Enclosure 5 to Serial: HNP-98-188

SHEARON HARRIS NUCLEAR POWER PLANT  
DOCKET NO. 50-400/LICENSE NO. NPF-63  
REQUEST FOR LICENSE AMENDMENT  
SPENT FUEL STORAGE

TECHNICAL SPECIFICATION PAGES

Figure 5.6.1: Burnup Versus Enrichment for PWR Fuel

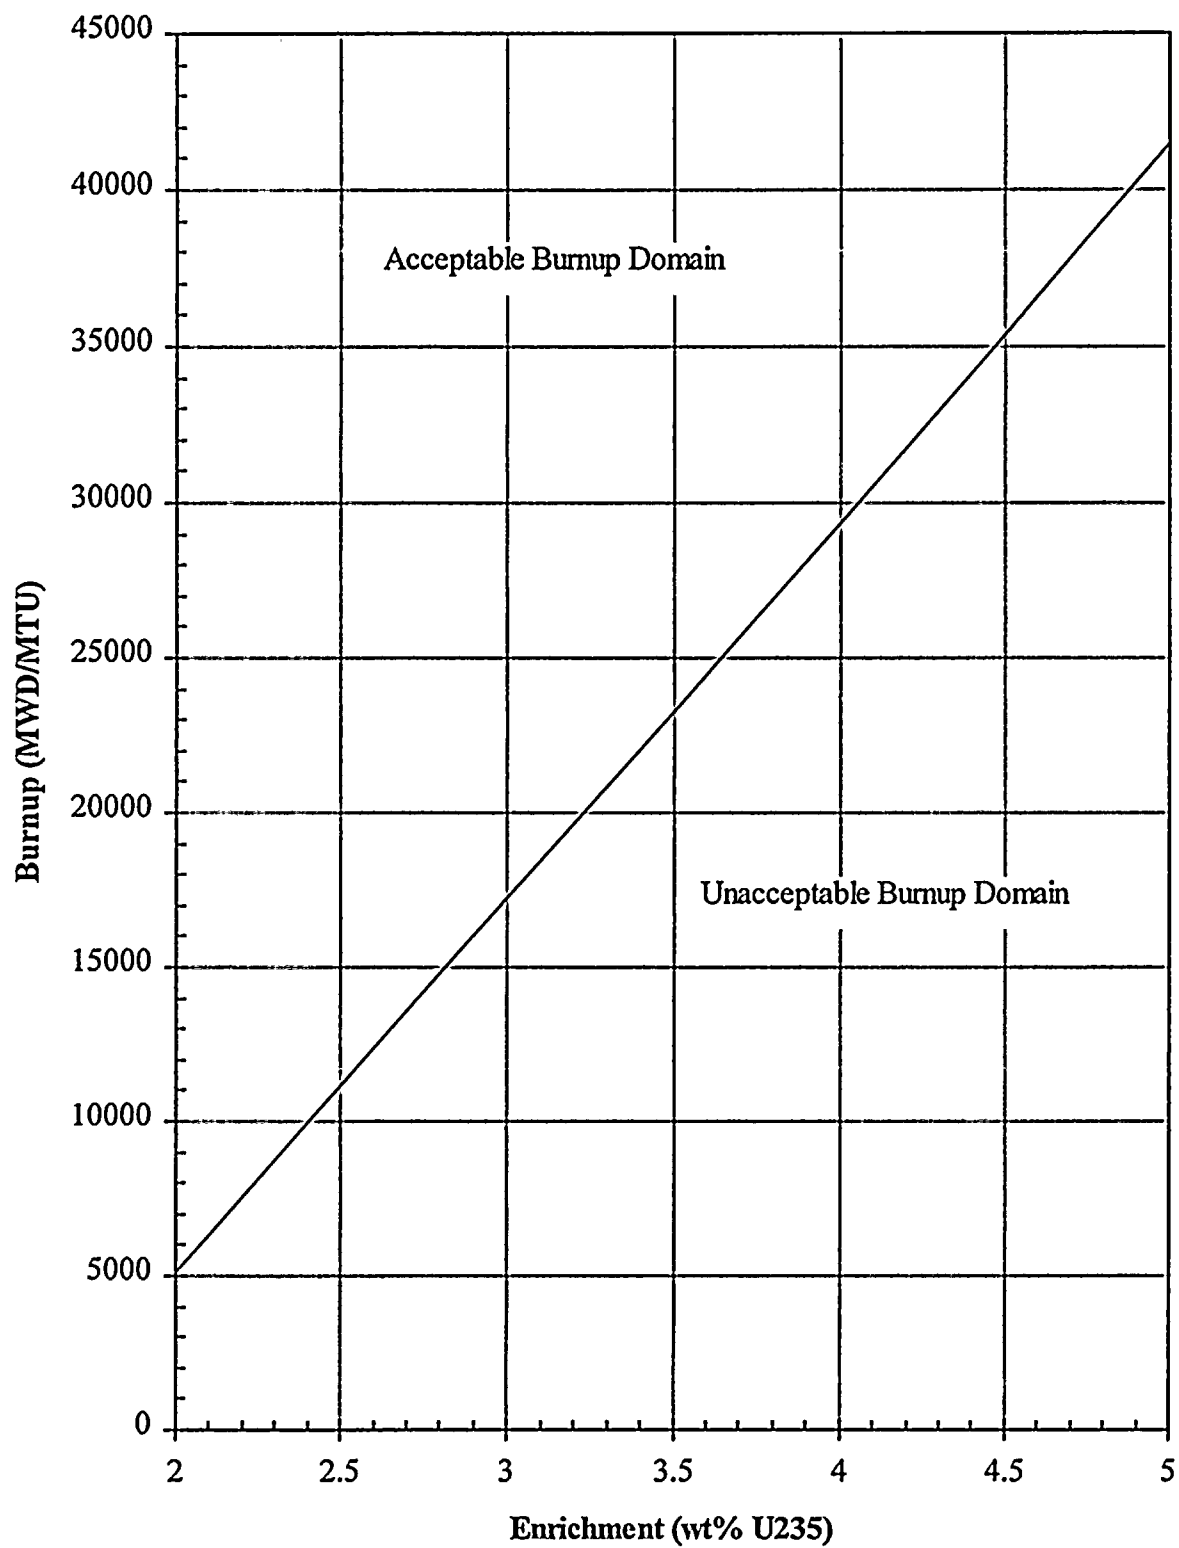
- a. PWR assemblies must be within the "acceptable range" of the burnup restrictions shown in Figure 5.6.1 prior to storage in Pools 'C' or 'D'
  - b. BWR assemblies are acceptable for storage in Pool 'C' provided that the maximum planar average enrichments is less than 4.6 wt% U235 and  $K_{inf}$  is less than or equal to 1.32 for the standard cold core geometry (SCCG) .
